Service Bulletin

Bulletin #: **SB- 595-003** Rev: **00**

Subject: Side Shift Transducer # C1079929 (Duncan Electric #109R2.4KL.074) is no longer available.

Material supplied with the Keen Engineering transducer

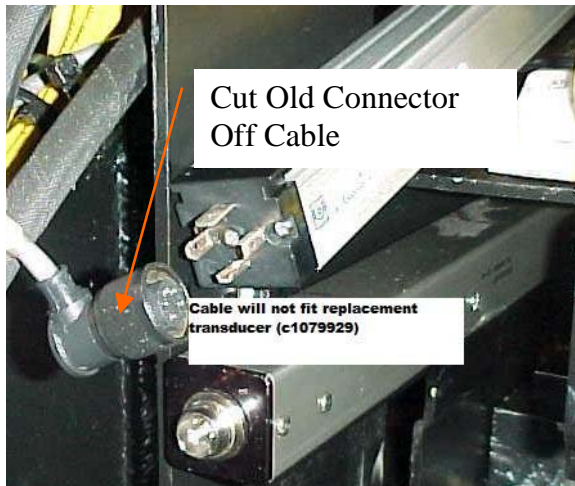
The **Duncan Electric** side linear transducer has been replaced by #KTC-225-02 transducer from **Keen Engineering**.

The Jervis B. Webb Company part number C1079929 has not changed. However the transducer is not a direct replacement due the use of a different connector by Keen Engineering. The new connector is supplied with the Keen Engineering transducer and must be used to replace the existing connector currently used with the Duncan Electric transducer.

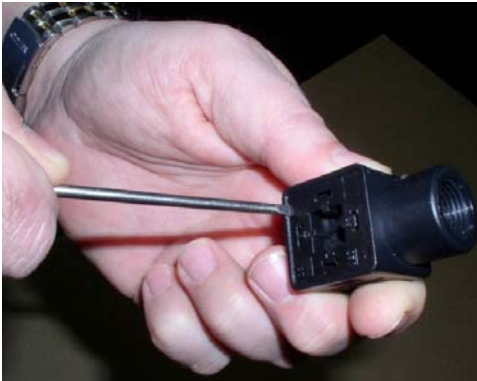
Use a small screwdriver to pry the contact plate out of the housing of the new connector. See the following illustrations.

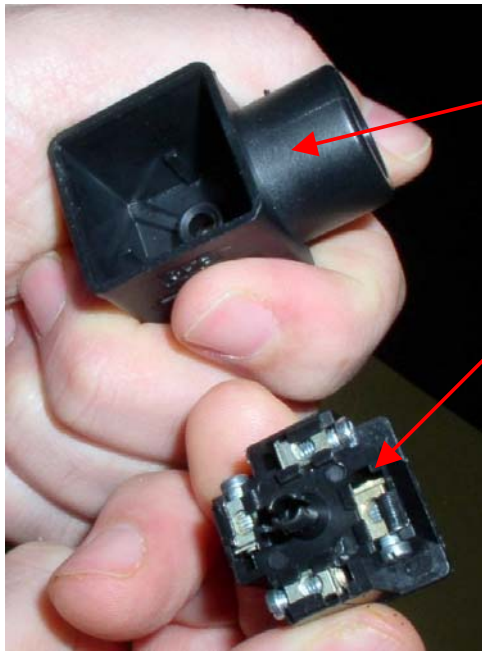
Housing

Contact
Plate

Push cable through the housing as shown

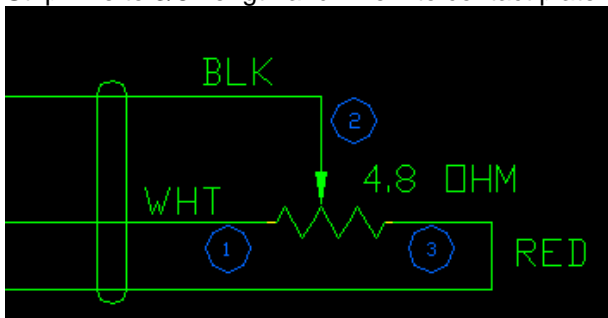
Strip wire to 3/8" length and wire into contact plate using the following wiring diagram

Contact plate pin out

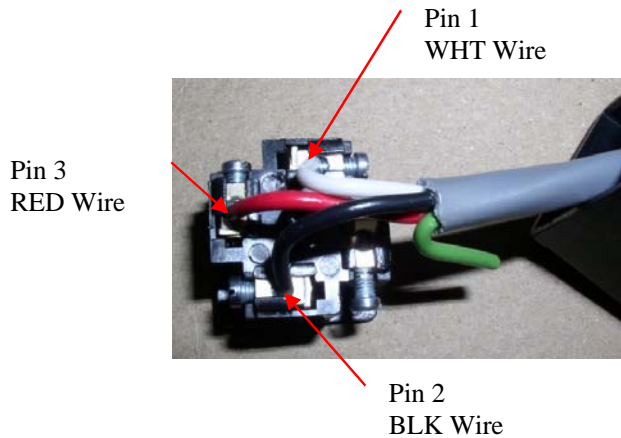
Turn plate over and wire as shown and per the diagram shown earlier

After wiring the connector push it securely back into the housing.

Place
Gasket
over
Pins

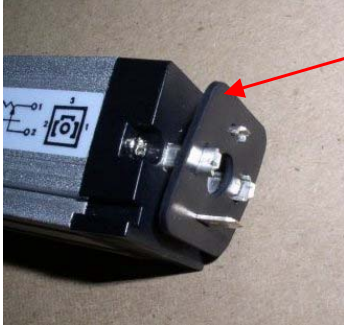
Place gasket over the transducer pins

Secure the connector to the transducer using the supplied retaining screw.
